# Scoped Amendment - Macassa Mine

December 16, 2021

Emergency Egress for Near Surface Portal

KIRKLAND LAKE GOLD

FIGURE 5-3.1 EGRESS SECTION

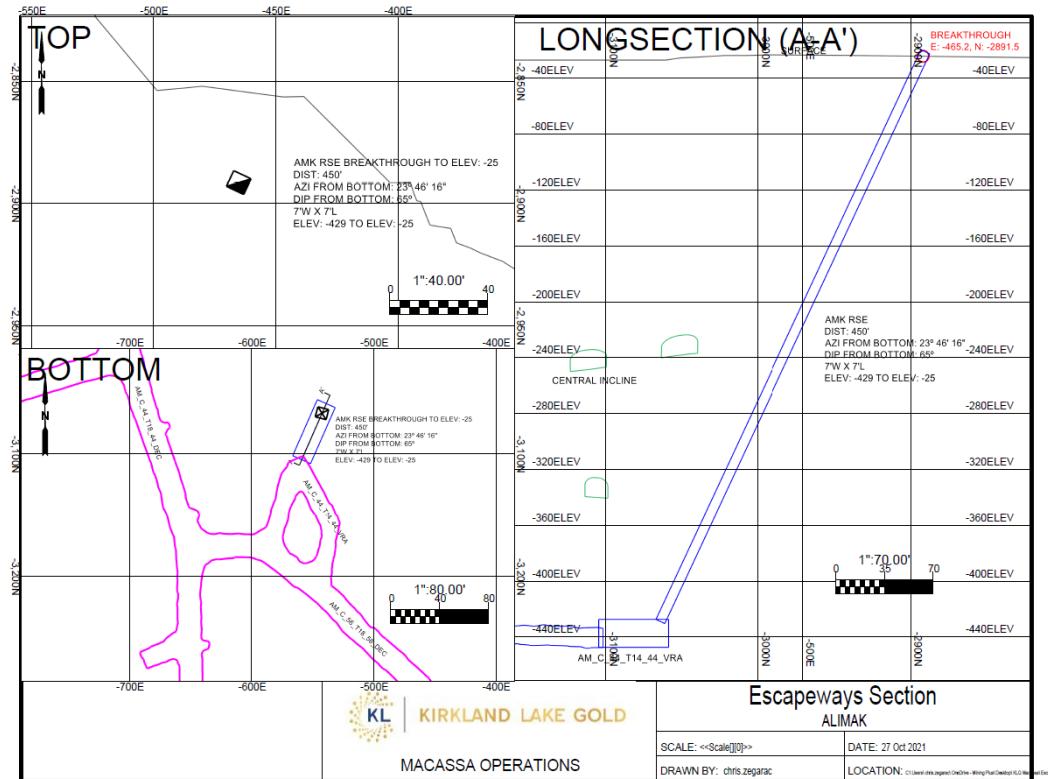
The construction of an emergency egress for the Near Surface Portal will provide an alternate exit from underground in the event of an emergency. The 8'x7' square raise will start underground at a depth of approximately 300ft and will open to surface, as shown in the following figures.

FIGURE 5-3.2 NEAR SURFACE EGRESS LOCATION

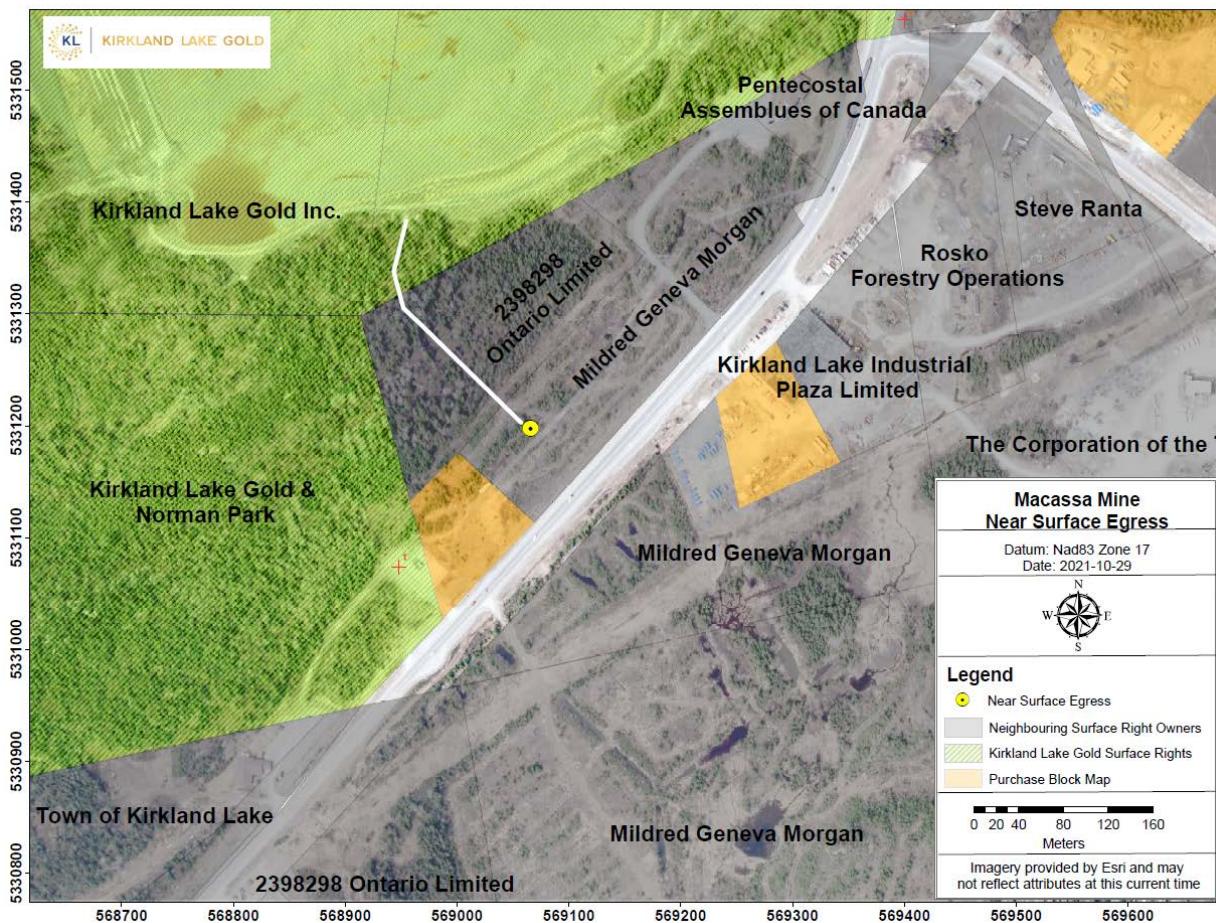
A 500ft access road from the site to the egress location will also be constructed in order to maintain and access the area. This will involve clearing approximately 0.07ha of trees. A structure will be placed over the opening and a fence installed to prevent access to the public.
